FED. ROAD DIST. NO.	STATE	FED. AID PROJ. NO.	FISCAL YEAR	SHEET NO.	TOTAL SHEETS
HAWAII	HAW.	M-7600(1)	1978	22	198

GRADING, DRAINAGE & CONSTRUCTION PLAN
FORT WEAVER ROAD
STA. 57+77.64 TO STA. 70+00.00

GRADING, DRAINAGE & CONTRUCTION PLAN
FORT WEAVER ROAD
STA. 70+00.00 TO STA. 85+00.00
FORT WEAVER ROAD
ROUTE H-1 TO SOUTH OF
FARRINGTON HIGHWAY

DETAIL OF CONCRETE JACKET
Scale: 1/2" = 1'-0"

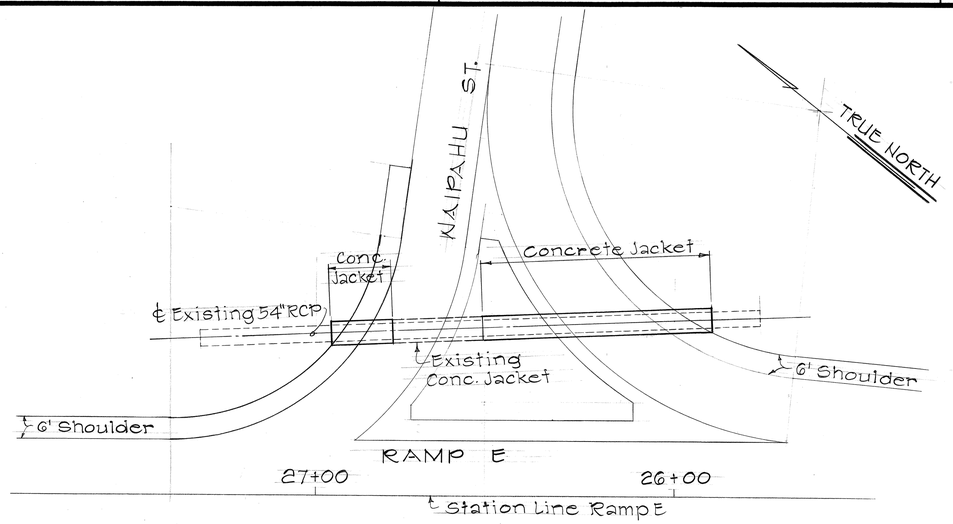
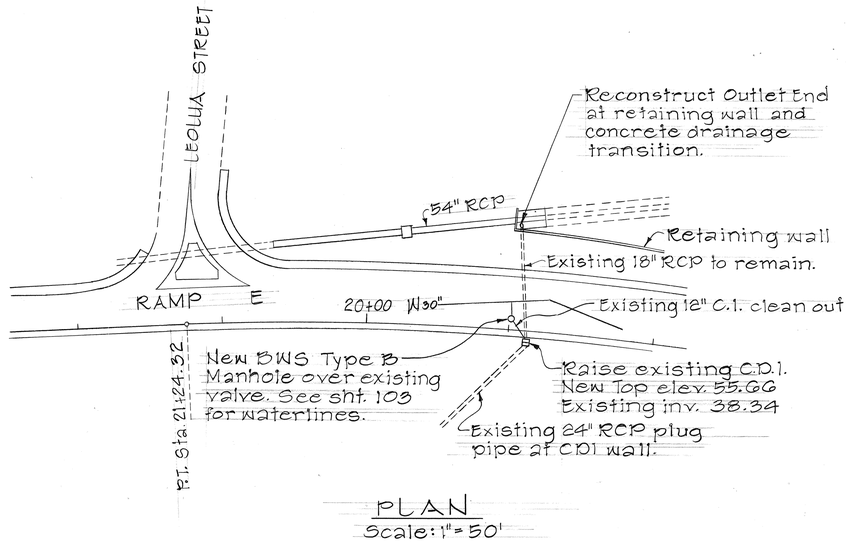
1. Delete Note in Contract Plan Sht. 25 "Remove existing CB and pipes."
2. Plug existing 24" RCP in CDI wall with Class A Concrete.
3. Remove and dispose existing CDI frame and grate. Use new ©1614 frame and grate.
4. Expose existing reinforcing 1'-6" from top of existing CDI and add new reinforcing as shown in C.D.I. detail sht. no. CO 31 S-3.
5. Raise existing CDI as shown in C.D.I. detail sht. no. CO 31 S-3.
6. Delete Note in Contract Plan Sht. 57 "Existing 18" CMP to be cut and plugged at both ends prior to wall construction."
7. Existing 18" RCP will remain, cut outlet end as required and modify outlet at retaining wall and concrete drainage transition as shown in 18" Pipe Outlet detail sht. no. CO 31 S-3.
8. Construct new Type B Manhole over existing control valve. Use BWS Water System Standards Fig. C, 7 & 8.
9. Refer to Notes in Contract Plan Sheets 100 and 101.

SPECIAL MANHOLES
RAMP E STA. 19+74 ± % 63' RT.
STA. 21+90 % 45' RT.
STA. 23+20 % 45' RT.

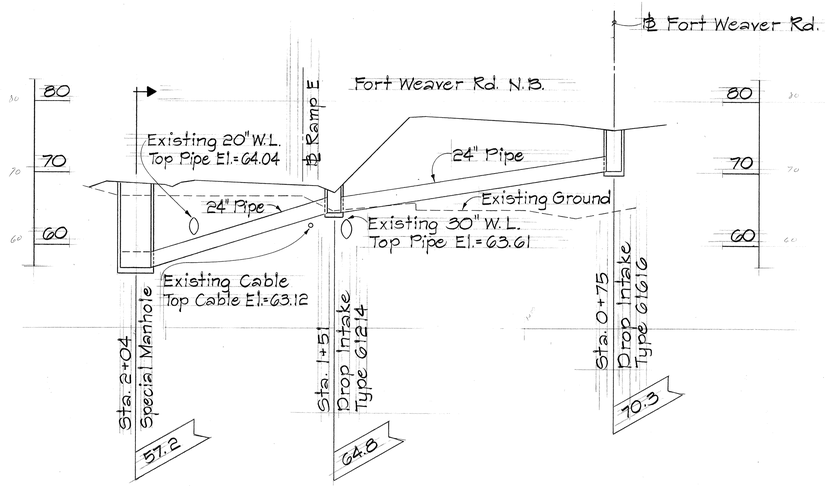
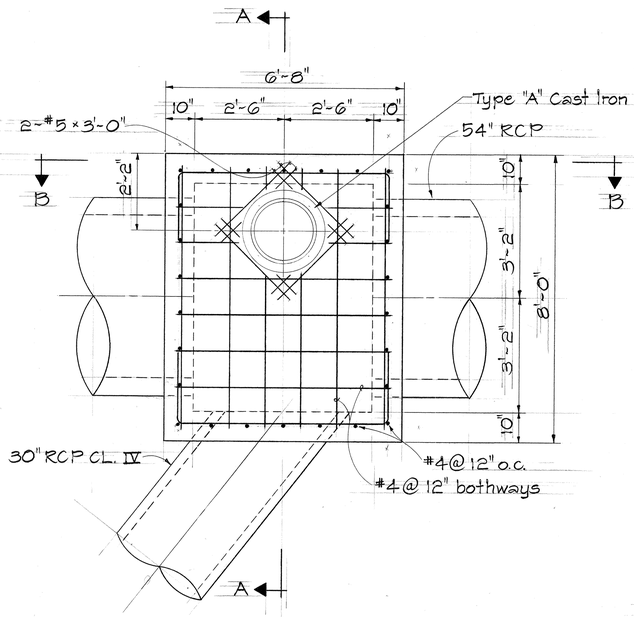
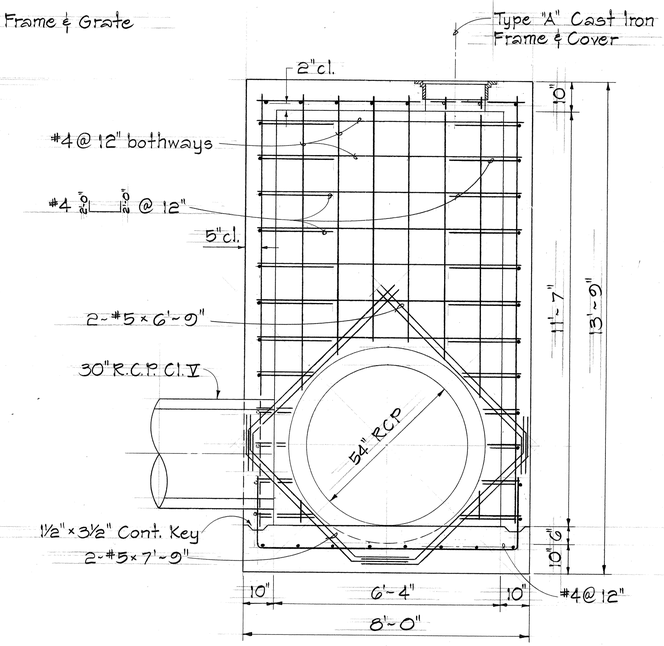
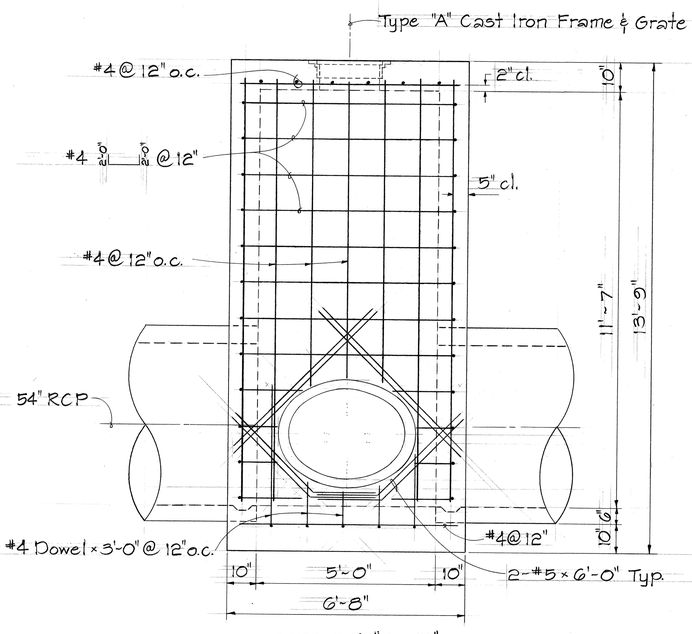
6 Special Manhole
Ramp E Sta. 23+20,
45' Rt., Inv. = 61.80, 24"
Inv. = ~~59.37, 60"~~ 57.20, 54"
For detail see Sheet
No. 31
C.O. 315-7

13 Spec. Manhole
Ramp E Sta. ~~20+40, 52' Rt.~~ 19+74± 63' Rt.
Inv. = ~~47.34~~ 42.50
For details see Sheet
No. 31 C.O. 315-7
